CITY OF WEST DES MOINES STAFF REPORT COMMUNICATION

Meeting Date: May 9, 2022

ITEM: Valley Southwoods, 625 S. 35th Street – Approve Major Modification to Site Plan to allow approximately 42,000-sq. ft. of building additions – West Des Moines Community Schools – MaM-004976-2022

Resolution: Approval of Major Modification to Site Plan

EXTERIOR ELEVATIONS

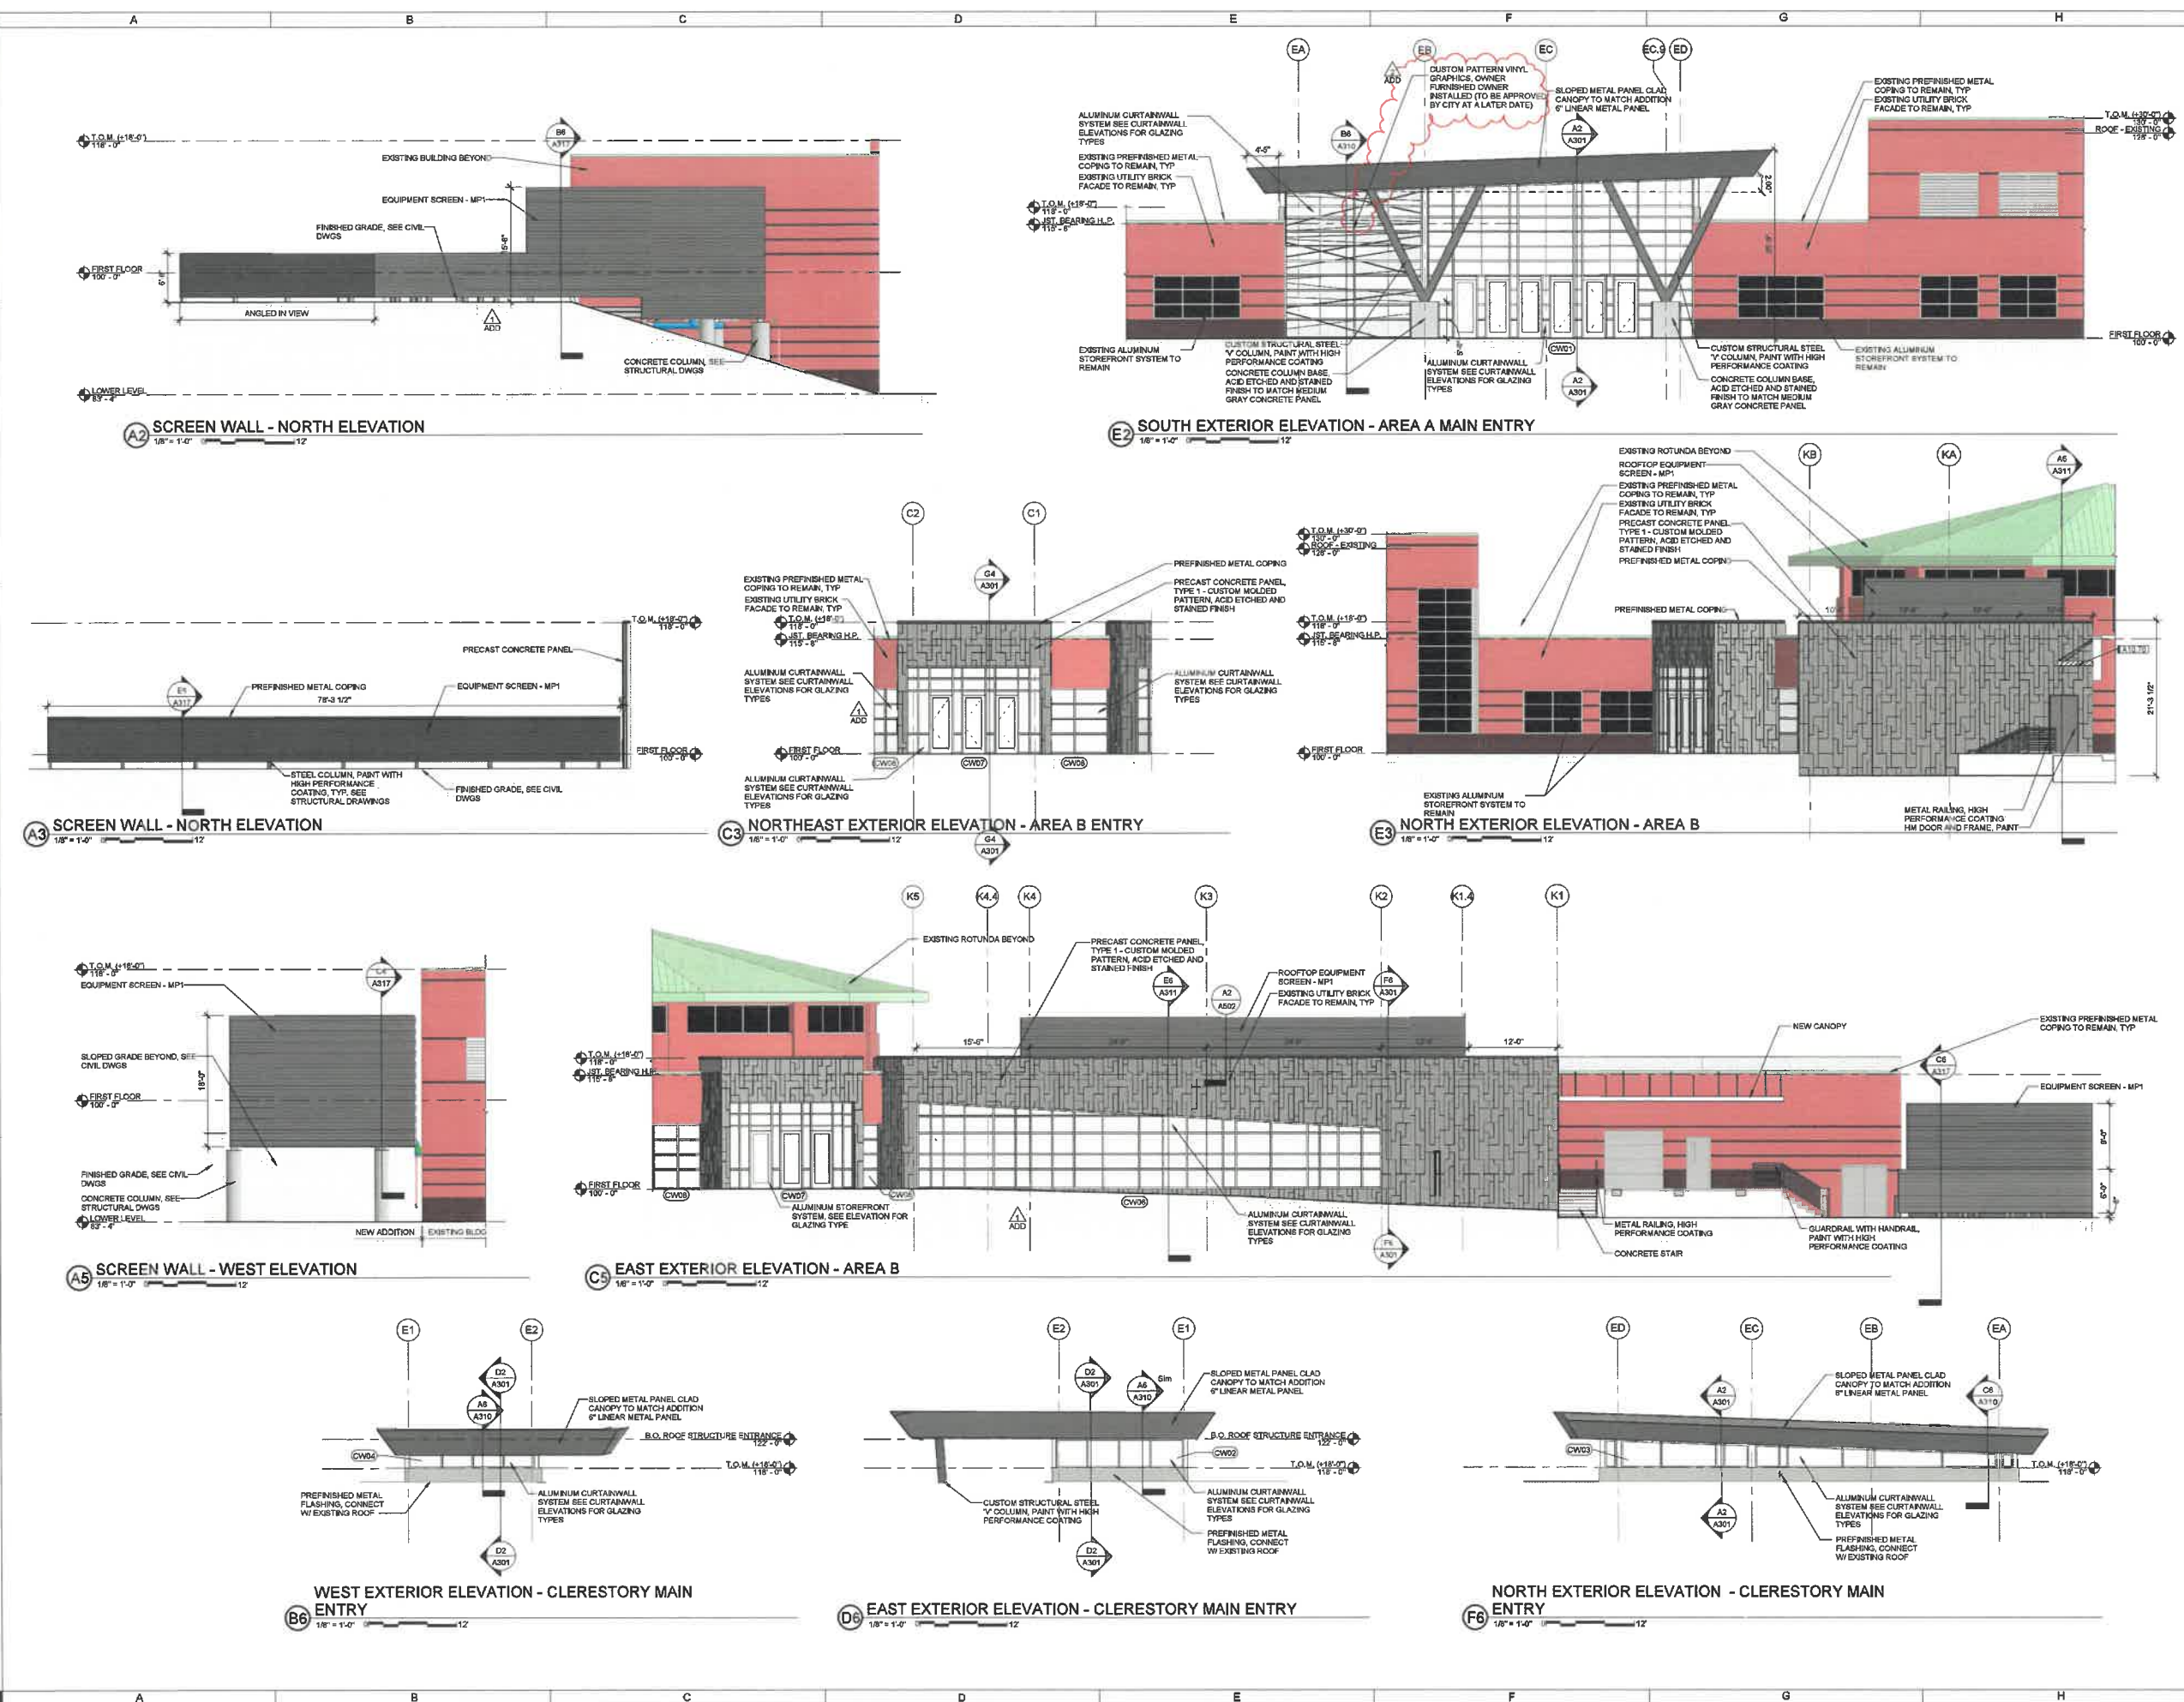
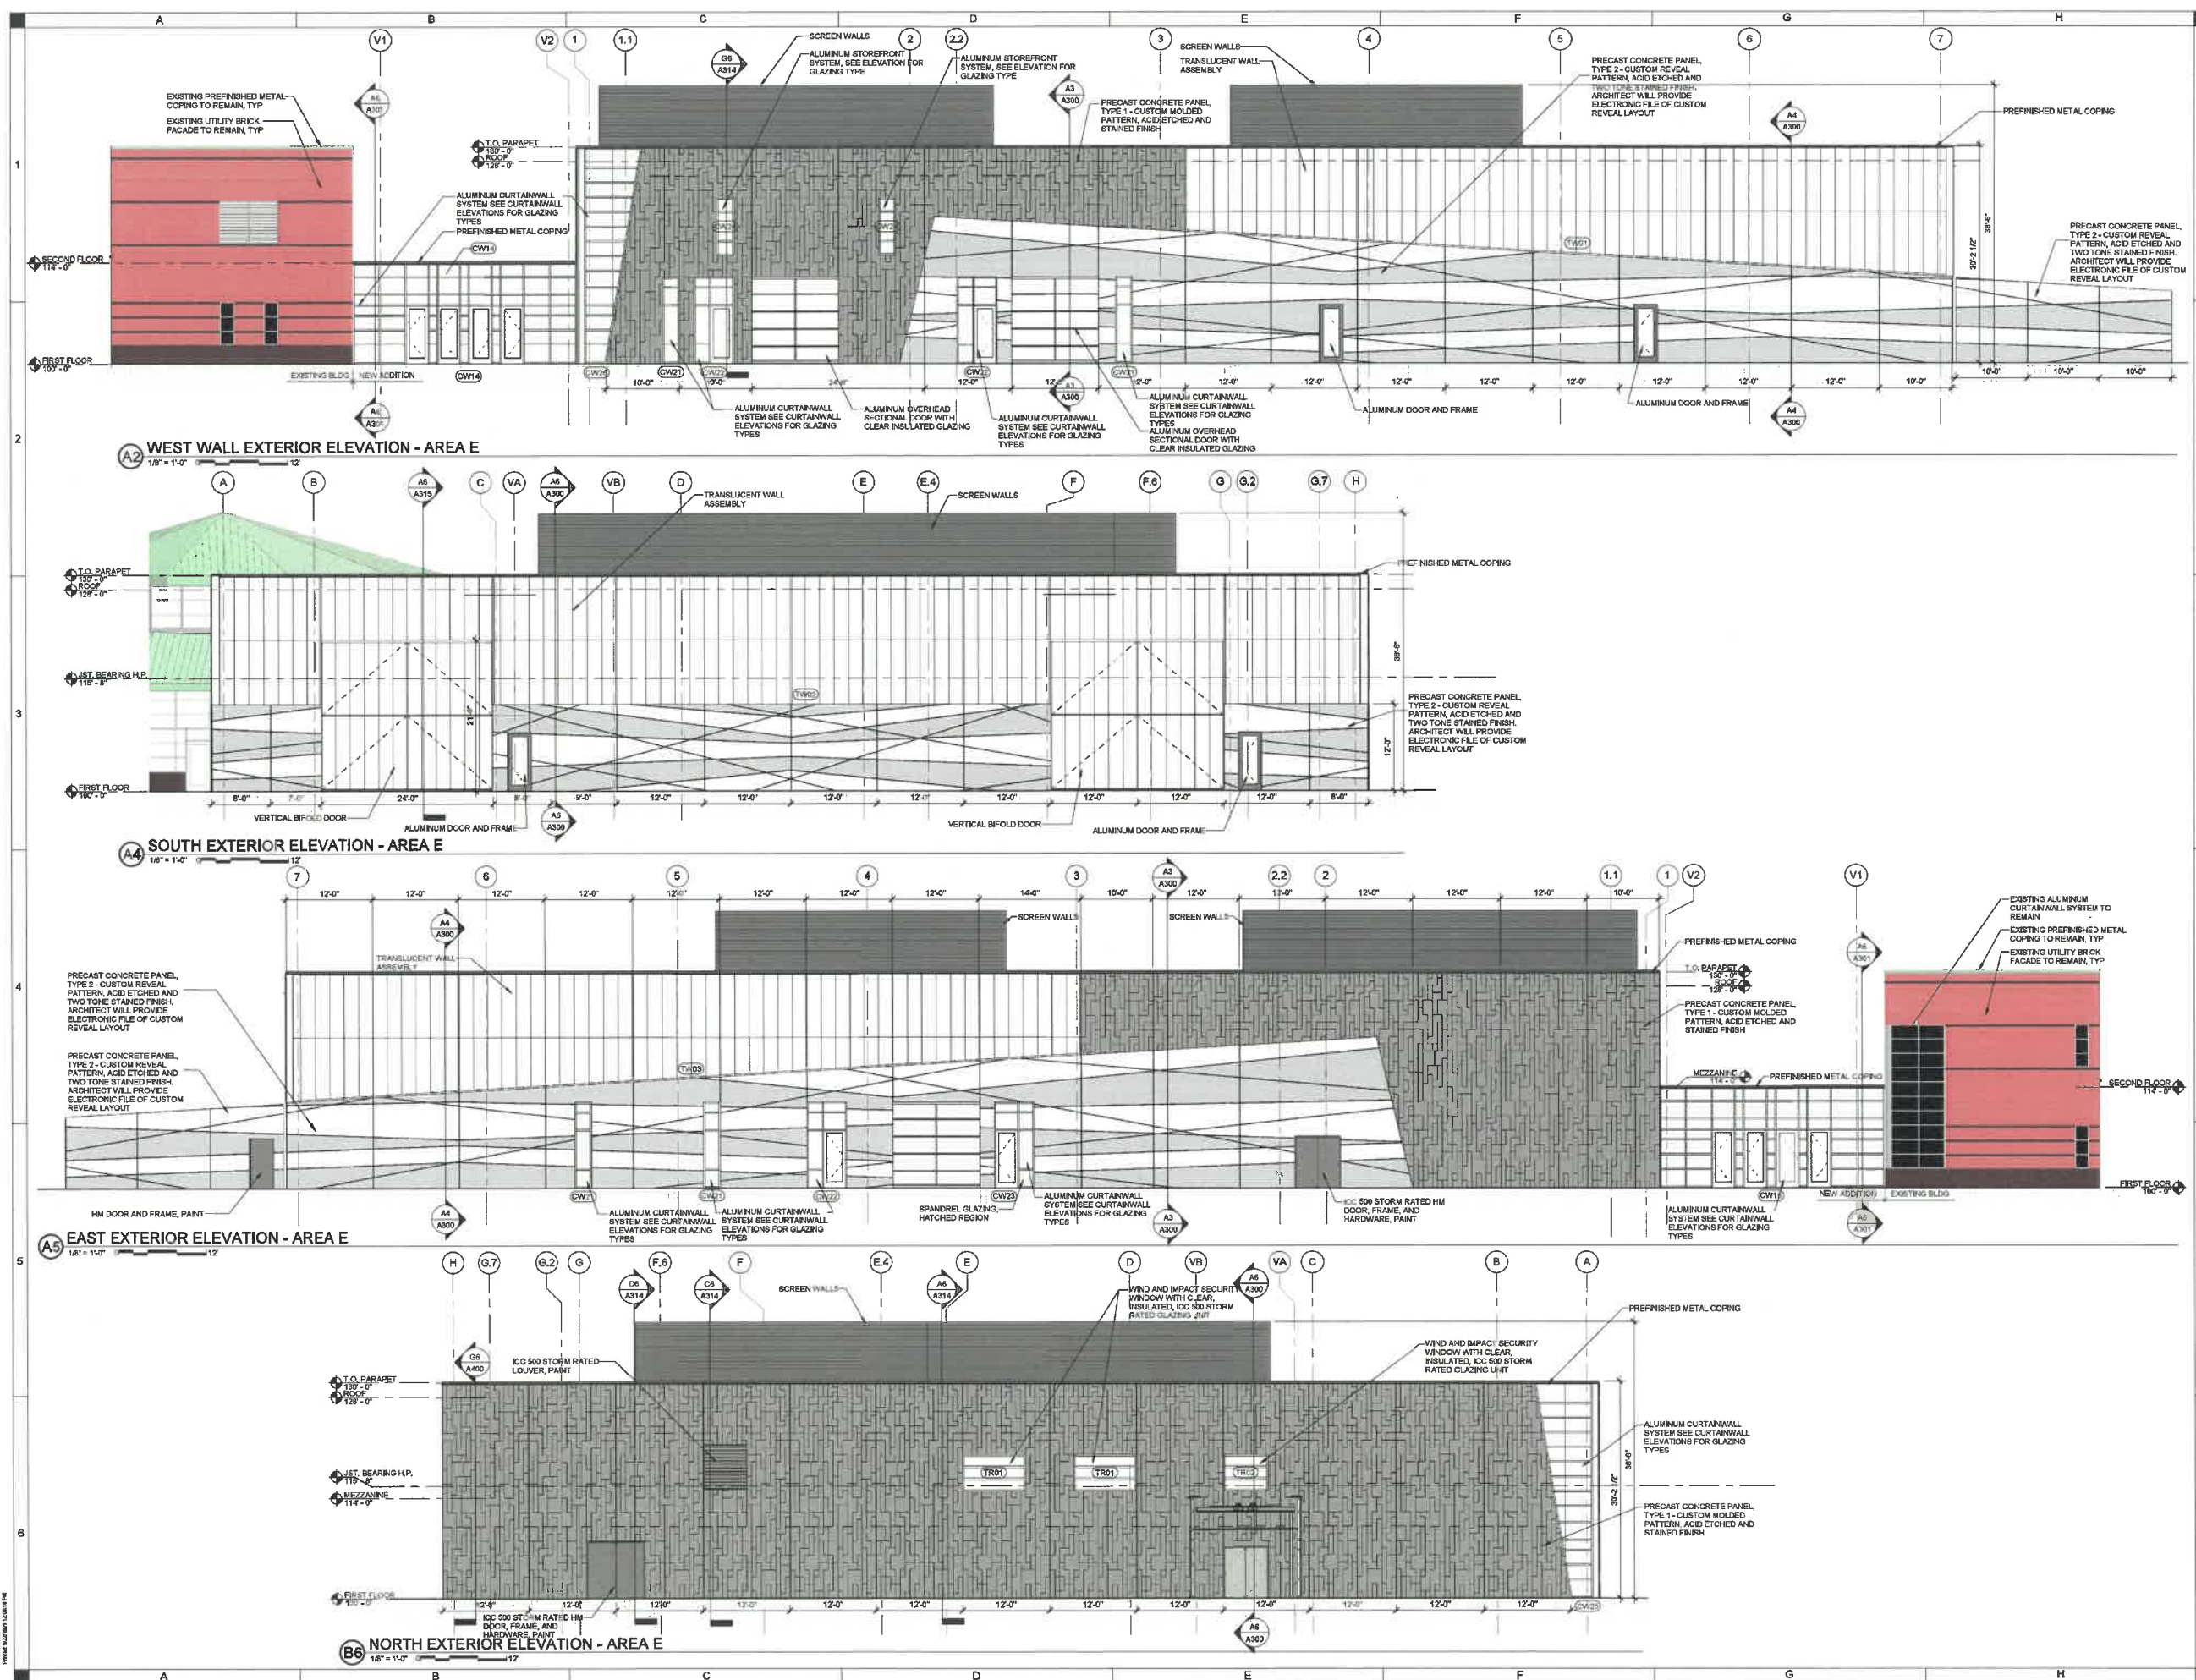
Staff is not opposed to a more unique design element for the new building additions as desired by the applicant, however staff has suggested that some design elements should be compatible from the existing building design to the new to provide an element of continuity of design from the old to the new. This could include elements such as massing, materials, color, design details, etc. Staff feels there is still a disconnect between the two design intents.

Staff still would like to see better cohesiveness between the new and existing elements of the building. Staff understands that the roof and windows may be changed out at some point in the future to compliment this proposed new design intent however, when this may happen and the tracking to confirm this will happen at the time of those projects is difficult from the city standpoint. Therefore, staff still has a concern for the variation in design from the existing building. The applicant is unwilling to pursue further discussions on the building design with City staff. Therefore, staff is requesting input from the Plan and Zoning Commission on the concerns noted above and recommends a condition of approval that prior to issuance of any building permit the applicant continue to work with Staff, based upon direct input from the Plan and Zoning Commission, to find design solutions to achieve better cohesiveness between the addition and existing building.

5. Prior to issuance of any building permit, the applicant continues to work with Staff, based on direction from the Plan and Zoning Commission, to find design solutions to achieve better cohesiveness between the addition and existing building.
